Department of Energy
Washington, DC 20585

PROPOSED CHANGES TO THE
NEVADA NUCLEAR WASTE STORAGE INVESTIGATIONS PROJECT
EXPLORATORY SHAFT FACILITY

BACKGROUND PAPER
FOR THE
U.S. NUCLEAR REGULATORY COMMISSION
AND
THE STATE OF NEVADA
AGENCY FOR NUCLEAR PROJECTS
NUCLEAR WASTE PROJECT OFFICE

MARCH 1987

Figure 2. Three Dimensional Illustration of the Exploratory Shaft Facility (Proposed Location).

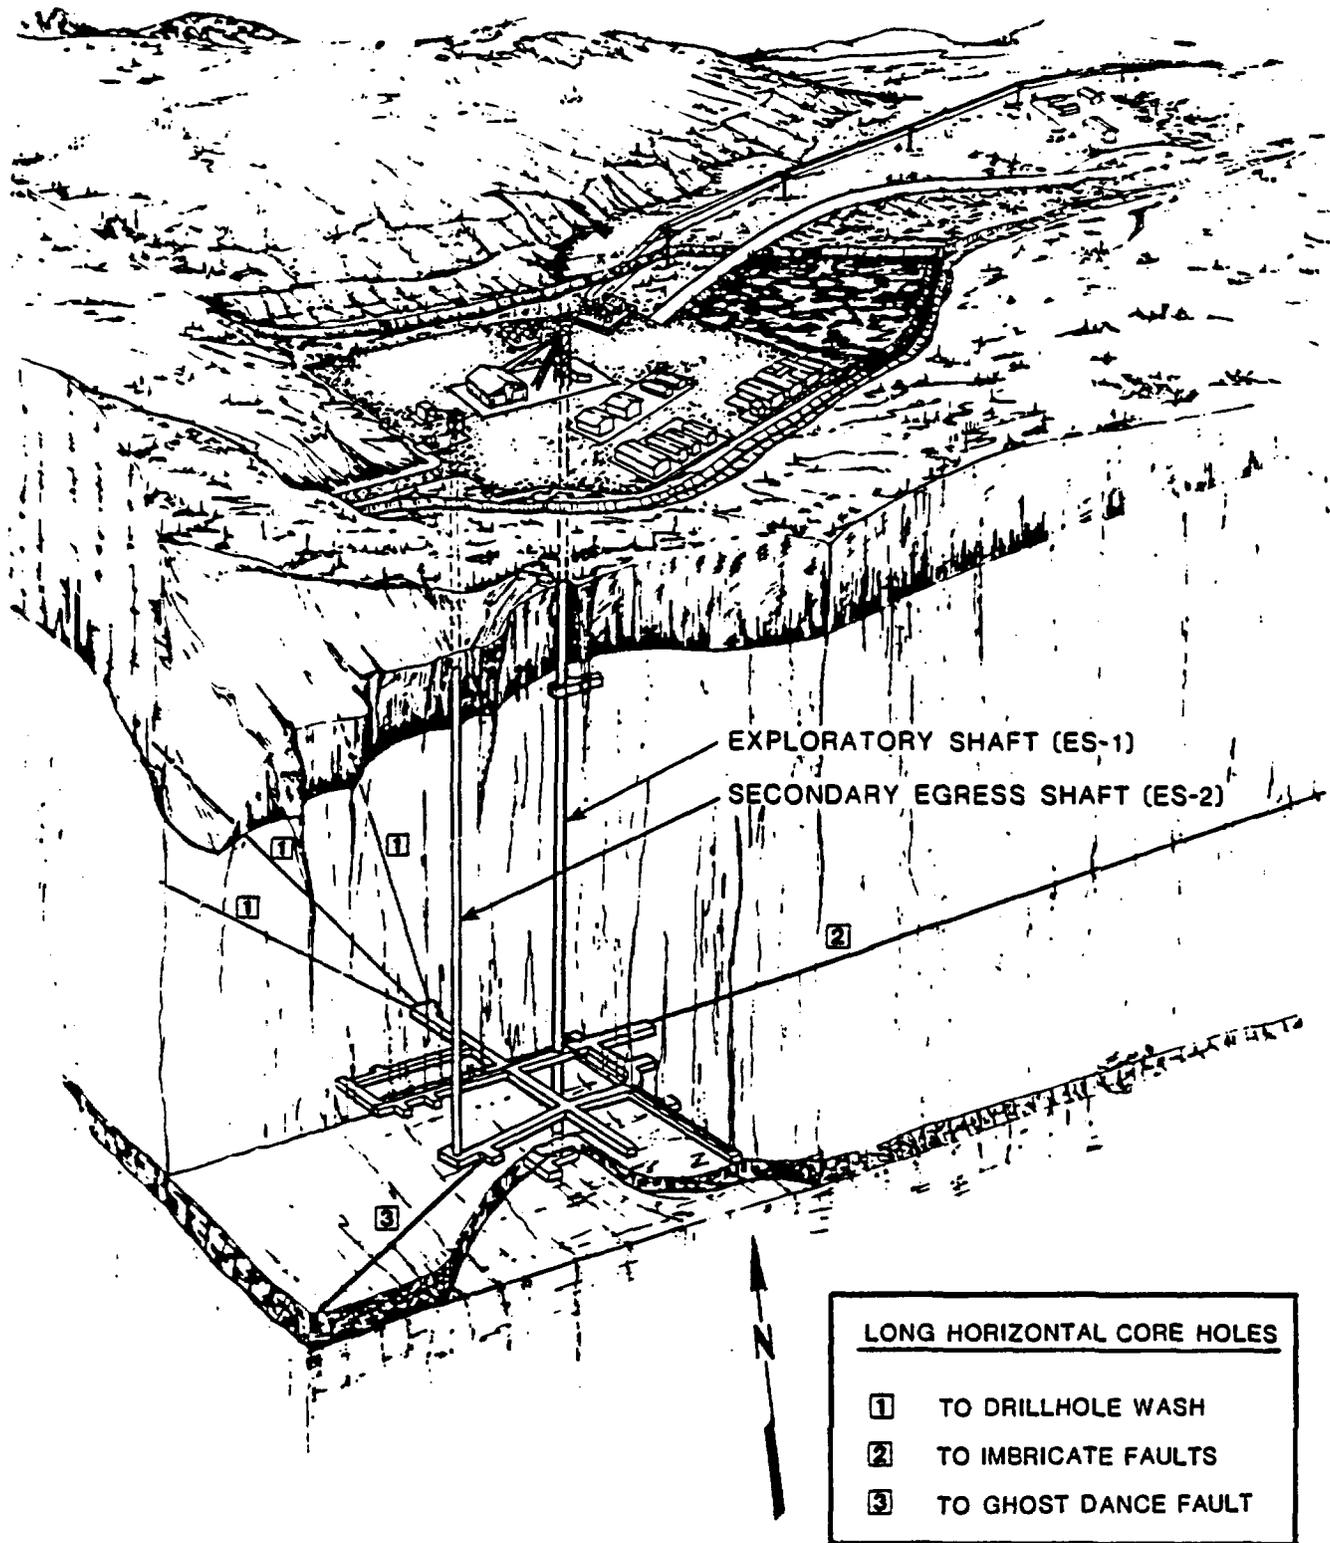
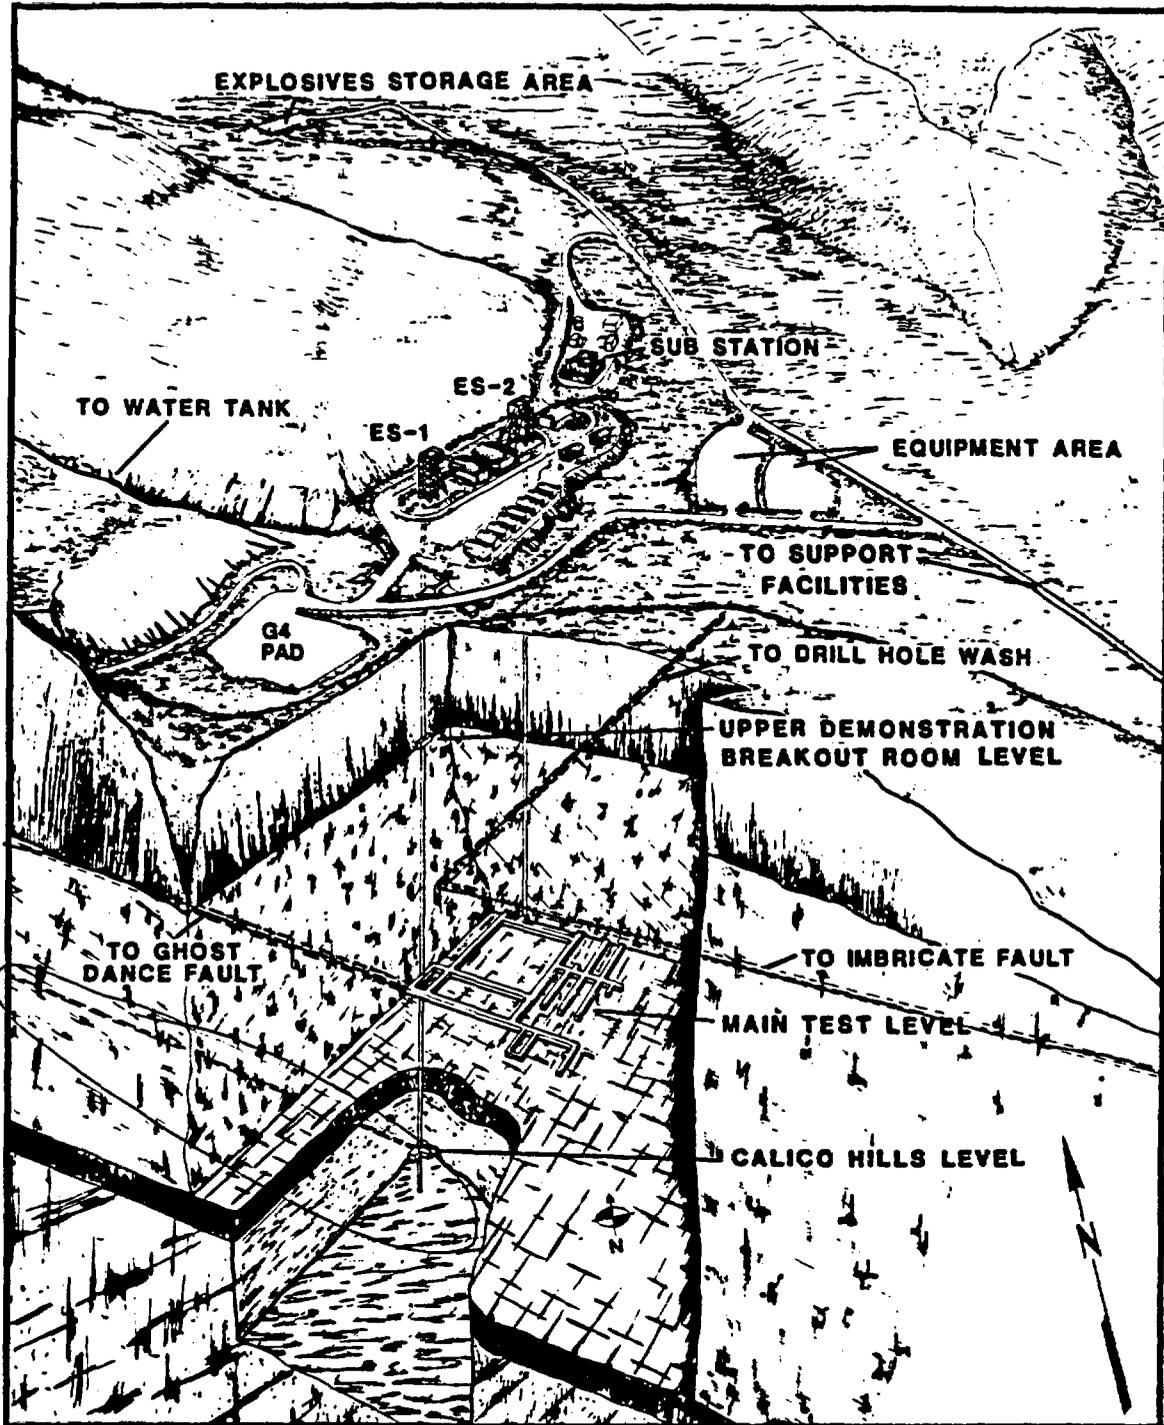
The changes that are proposed are outlined below. They are shown schematically on Figure 2.

- 1) Relocation of the ESF exploratory shafts and surface facility approximately 440 feet to the northeast.
- 2) Relocation of the main test level from the 1200-foot level to approximately the 1020-foot level.
- 3) Construction of approximately 5600 linear feet of exploratory drifts to the fault areas (Ghost Dance fault, Drill Hole Wash and the Imbricate Normal Fault System).
- 4) Expansion of the main test level complex by approximately 2500 linear feet of drifts.
- 5) Increasing the second shaft (ES-2) from a 6-foot to a 12-foot, inside finished diameter.

Figure 3. Comparative Illustration of the Final EA Versus the Proposed Exploratory Shaft Locations

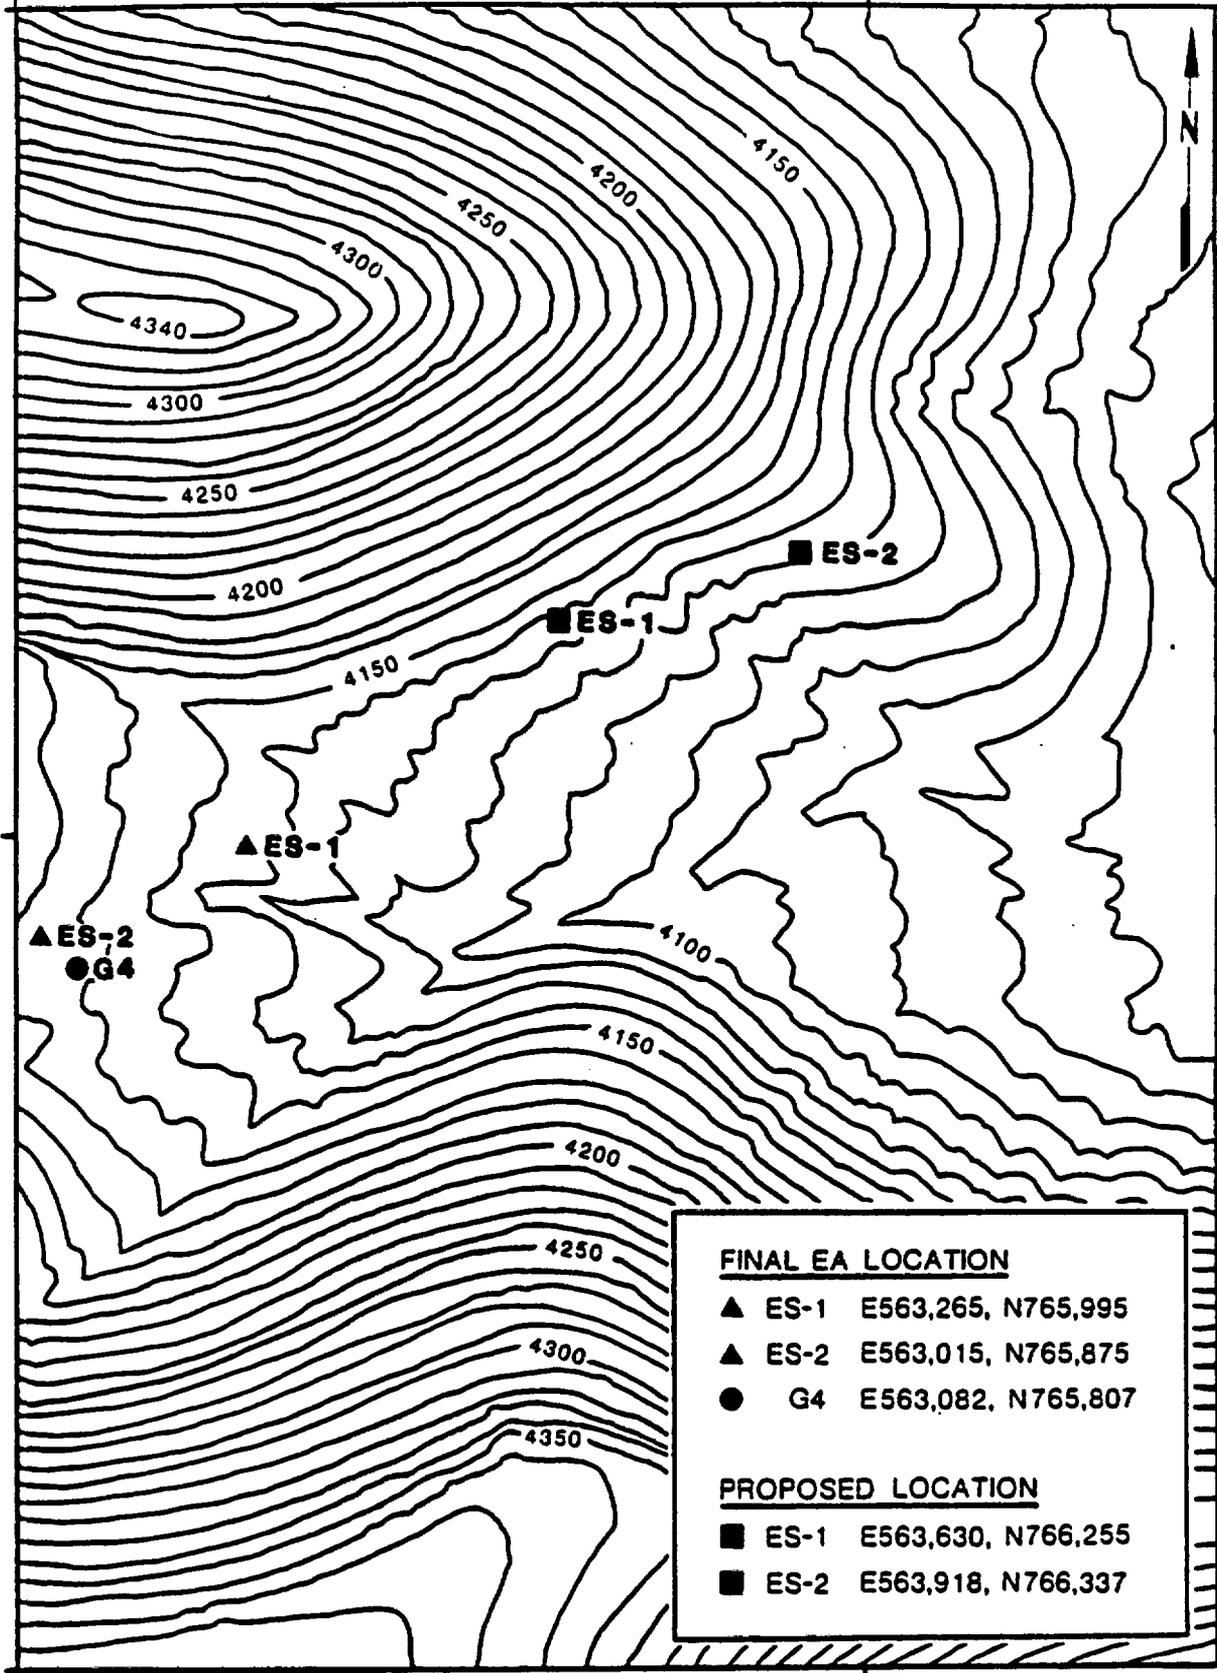
The NNWSI Project proposes to move the location of the first and second shafts 440-feet to the northeast of the location proposed in the EA, as shown in Figure 3. This will remove these shafts and their associated facilities from the middle of Coyote Wash and place them on a cut-and-fill rock shelf located on the side of the hill which bounds the wash to the northeast. The shaft collars will be located on the cut portion of the shelf anchored directly in bedrock at the surface. This proposed change will remove any limitations resulting from the current design and should alleviate the concerns raised by the NRC regarding flooding, erosion, and flow of water around the area of the shaft liners. Placing the shafts collars directly on bedrock also reduces concerns about their stability as potential future repository components.

Figure 4. Comparative Illustration of the Final EA Versus the Proposed Main Test Level Location.

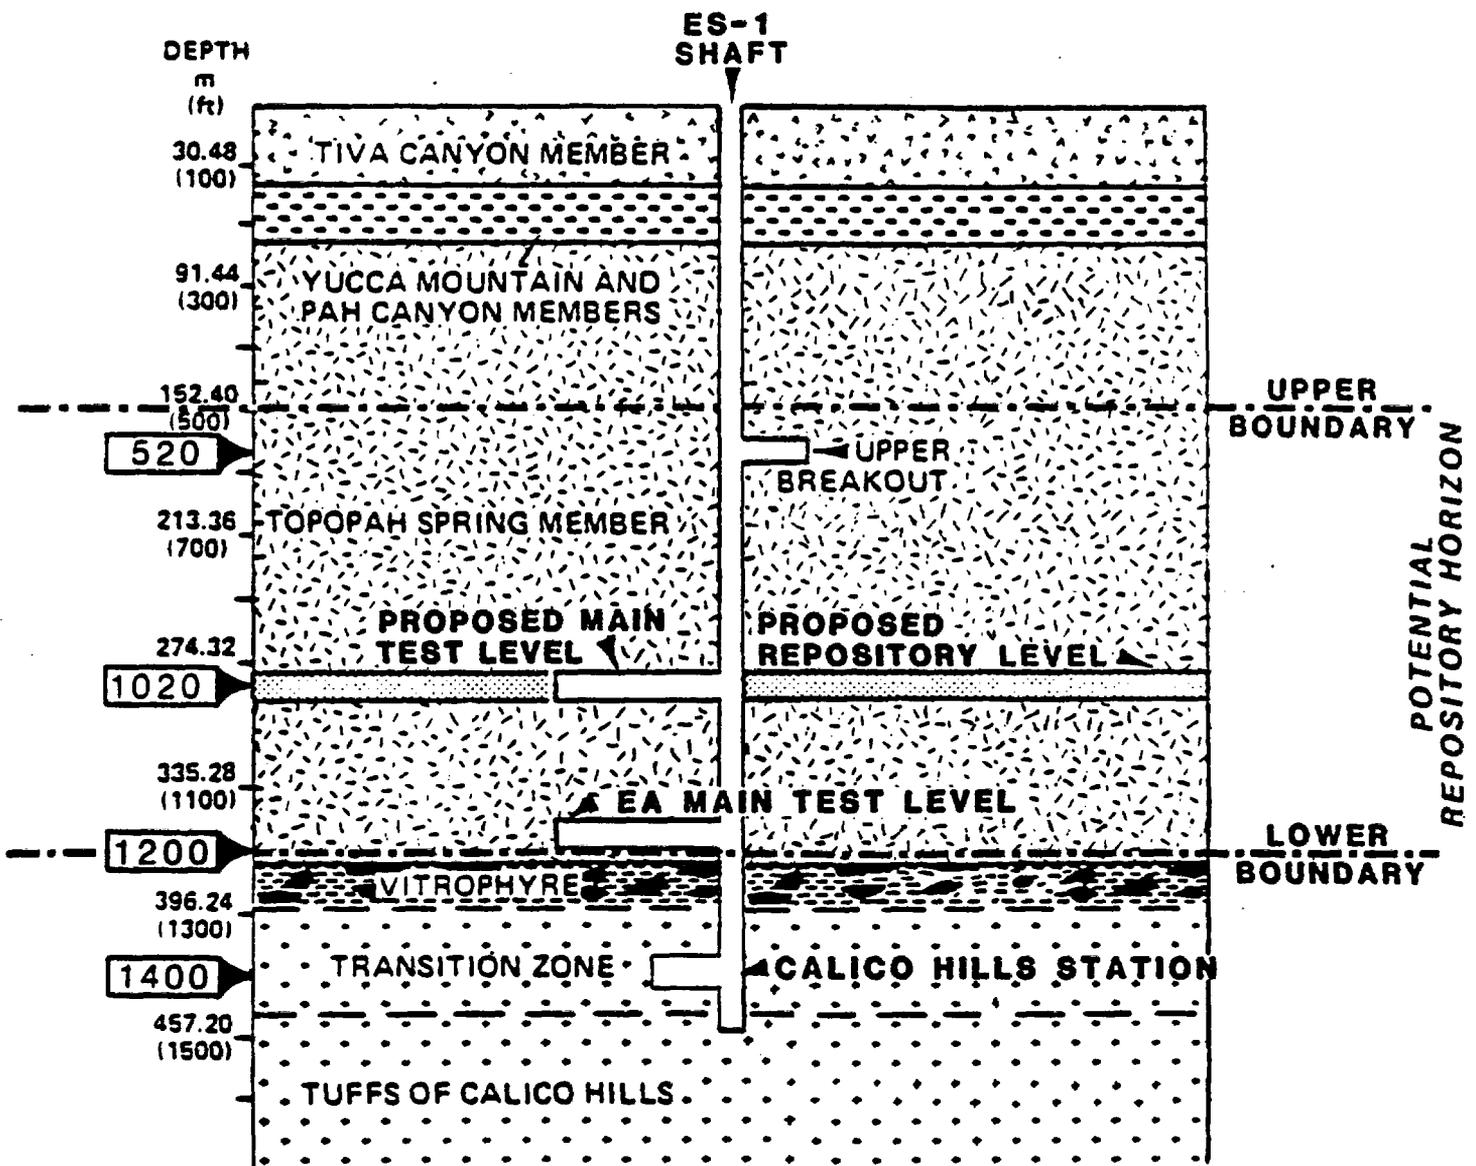
The NNWSI Project proposes to raise the main test level breakout from 1200 feet to approximately 1020 feet below the top of the ES collar. This change allows the main test level, with its proposed extensive drifting, to be at the same level as the repository in that particular lateral location of the Topopah Spring Member, as shown on Figure 4. Making this change would assure that the bulk of the scientific and engineering measurements would be made in a portion of the rock actually located in the repository and would minimize the mining of test areas beneath the repository. The 1020-foot level may have a geologic structure representative of the least desirable area to be encountered during construction of the repository. This would ensure that the data obtained from underground testing are conservative and can be used to analyze the worst case scenarios for performance of the repository.

Figure 5. Relationship of ESF long drifts and the conceptual repository design.

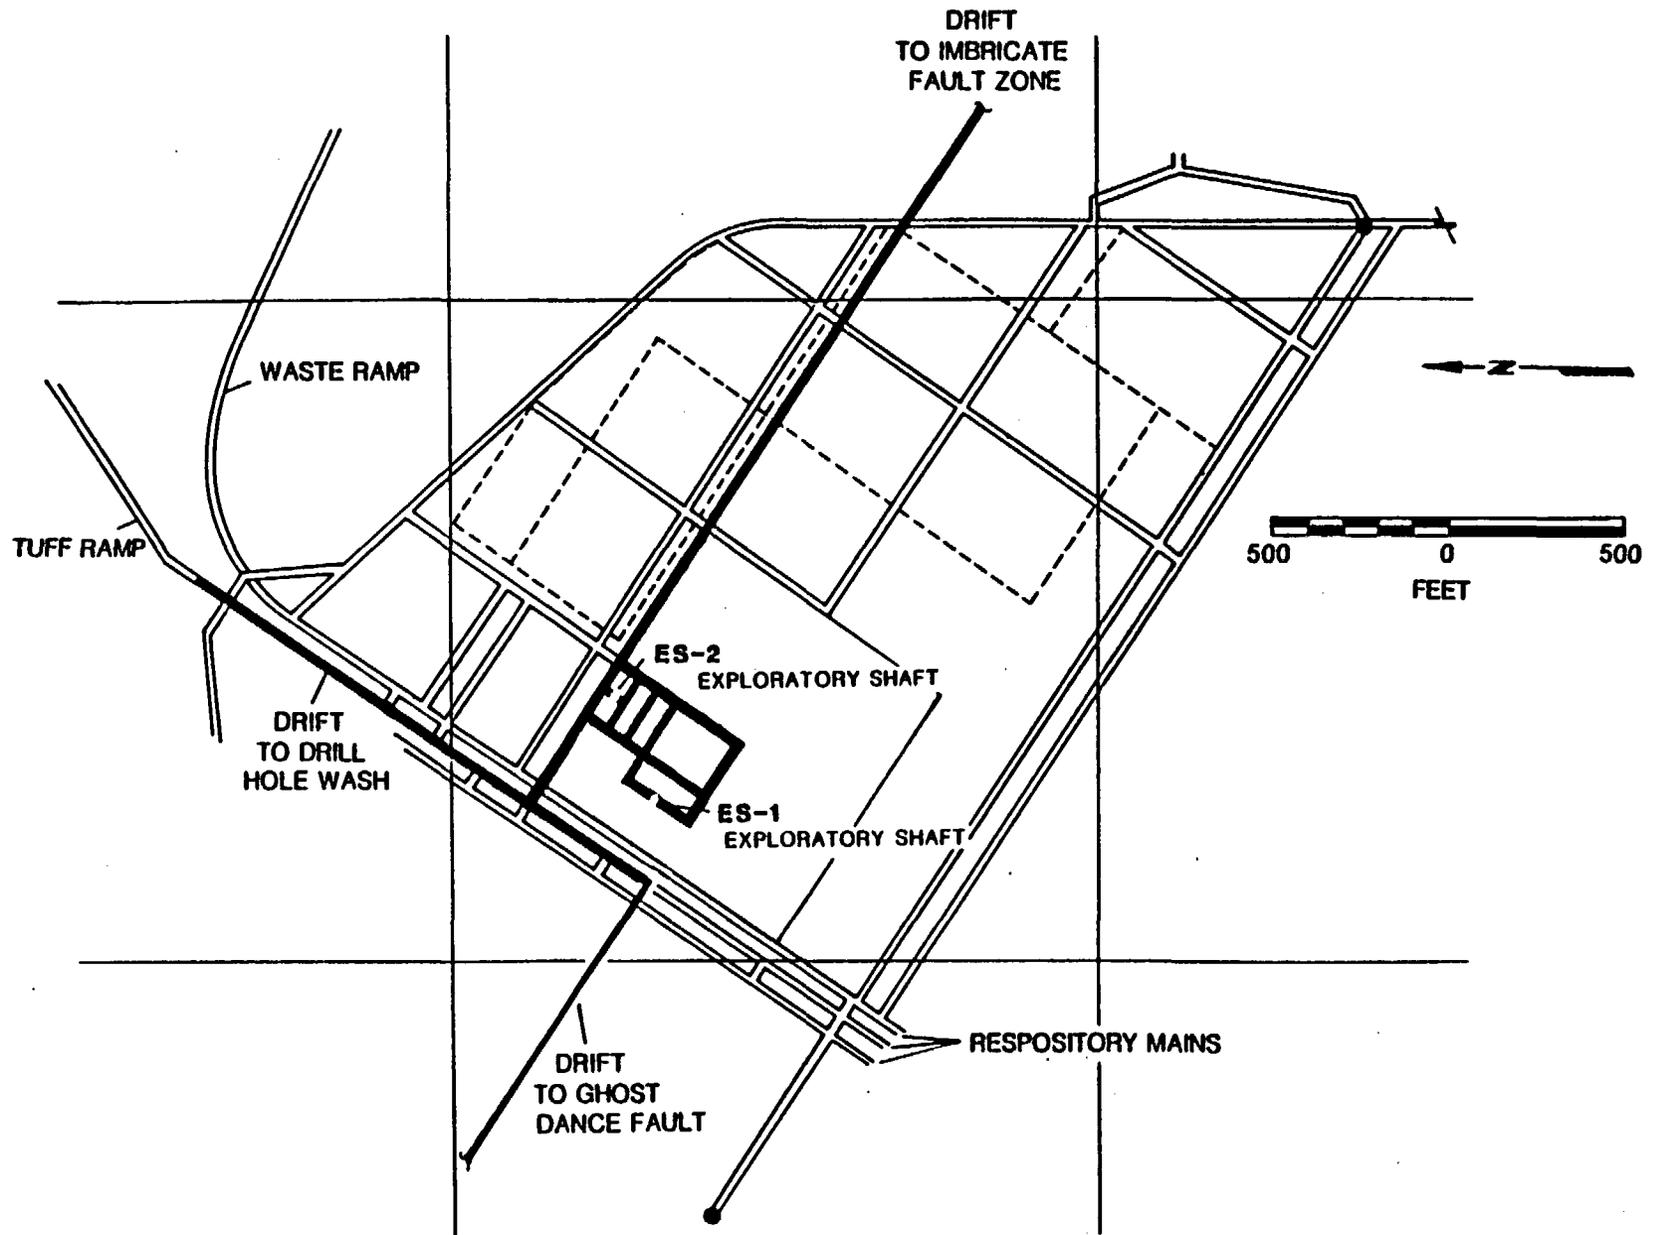
The NNWSI Project proposes to delete the long core holes described in the EA and perform the scientific investigations using full size repository drifts mined to each of the three fault areas of concern. Figure 5 shows the proposed drift arrangement. The long drifts would be positioned so that they can be used in the repository if this site is selected as the first repository.

proposed change represents an addition of approximately 5600 feet of exploratory drifts.
